CABINET MEMBER FOR ENVIRONMENT DELEGATED DECISION MEETING 9 OCTOBER 2014

PROPOSED PELICAN CROSSINGS – A415 MARCHAM ROAD AND OCK STREET ABINGDON – RE-CONSULTATION

**Report by Deputy Director of Environment & Economy
(Commercial)**

Figure 1: Location of Problems

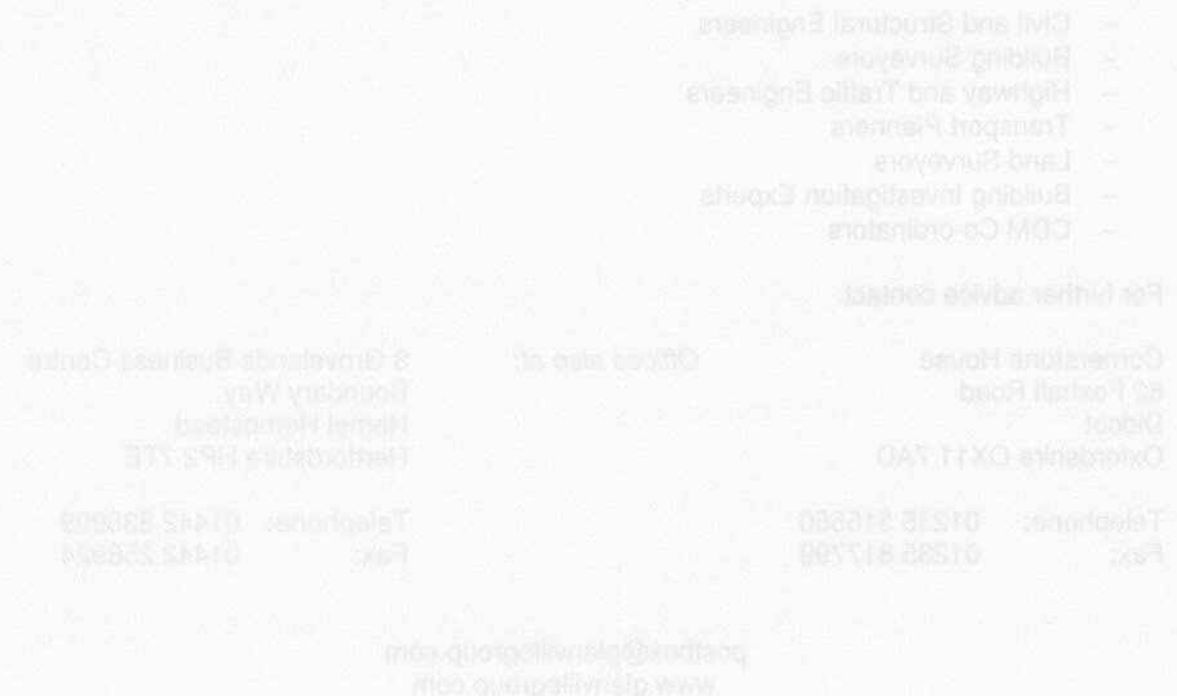
- 1.6 All comments and recommendations are referenced to the layout drawing at Figure 1 to indicate its location.
- 1.7 The Audit Team visited the site on Thursday 20 March 2014 between 11.30 and 12.45 hours to review the proposed highway works in context. During the site visit the weather conditions were dry and carriageways and footways were also dry.

- 4.3 In essence, the Audit Team concludes that by relocating the existing controlled crossing facility a 'safe' arrangement is being replaced by a 'less safe' arrangement in that pedestrians are less likely to use the controlled crossing facility in its revised location across Ock Street east of Drayton Road as this is no longer on their natural desire line for the majority of users and those that do will be exposed to increased risk of accident involving injury because of the need to cross more roads either where:
- no formal crossing facilities are provided or
 - facilities provided are sub-standard with no practical prospect of improvement.

4.9 Comment 9: Standard of crossing

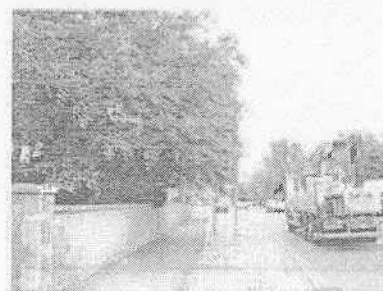
Summary: The drawings do not show the crossing layout to be as the Audit Team would have expected to see.

4.9.1 For no apparent reason, the signals layout is asymmetric with respect to the (differing) number of poles and secondary signals on the two sides of the road – two primary signals plus one secondary for westbound traffic but only one primary (on the inside of a gentle Left Hand bend in the road) plus one secondary for eastbound traffic. Traffic volume eastbound is likely to be the same as westbound and the Audit Team would have expected a symmetrical installation.
